Re: **LETTER OF TRANSMITTAL  
ROOMS TO GO STORE EXPANSION AND REMODEL  
18722 South Dixie Highway  
Cutler Bay, FL 33157  
POST BID ADDENDUM #5**

## **POST BID ADDENDUM NO. FIVE**

Incorporate the following revised CASCO drawings dated 01/29/2024, with revisions including, but not necessarily limited to, those listed below:

1 RISER DIAGRAM - EXISTING  
SCALE: NOT TO SCALE

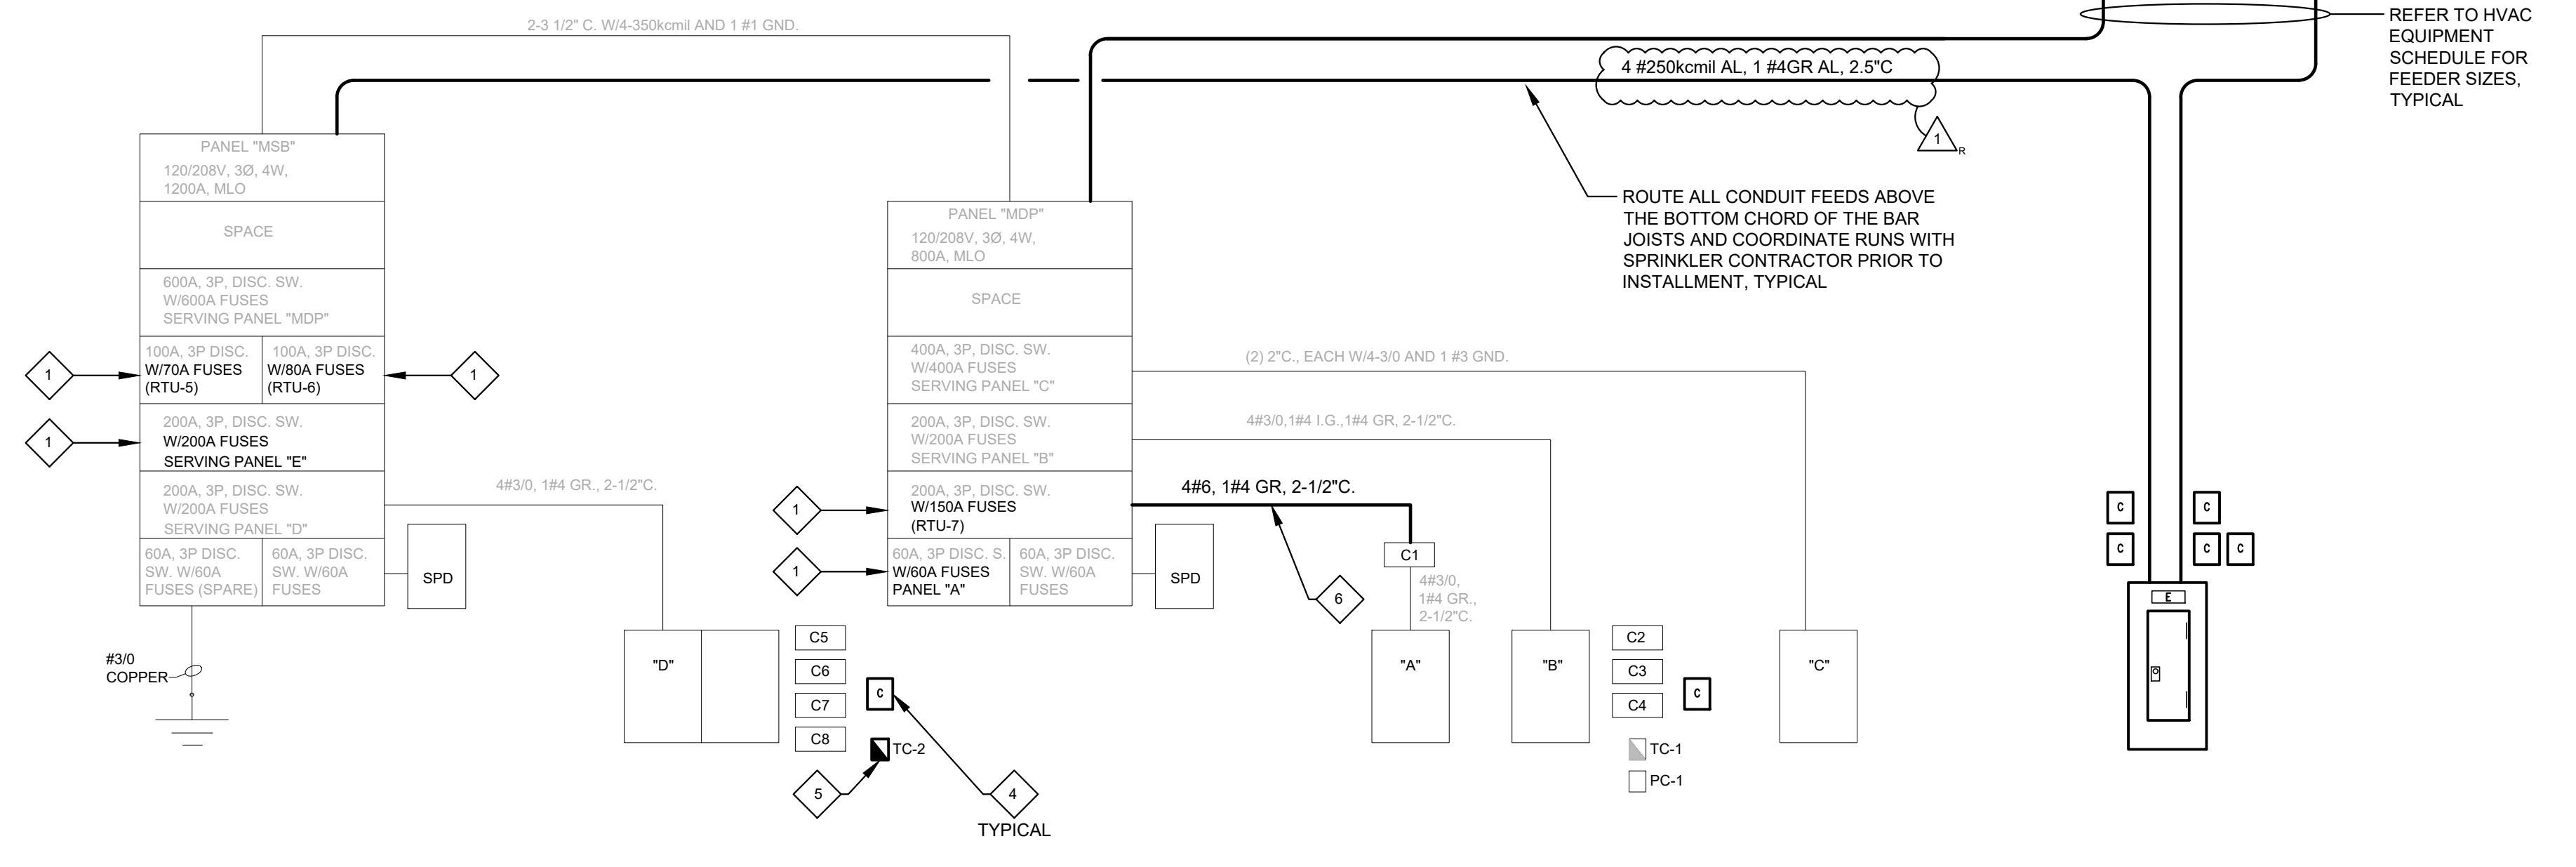
40. Sheet E4.0 – Revision No. 1: Revised one line diagram. Replaced feeder for panel E to aluminum.
41. Sheet E4.1 – Revision No. 2: Revised panel schedule D. removed two circuits for Breakroom receptacles from the schedule. Added circuit for sales receptacles to panel schedule D. Removed circuit for sales receptacles from panel schedule E.
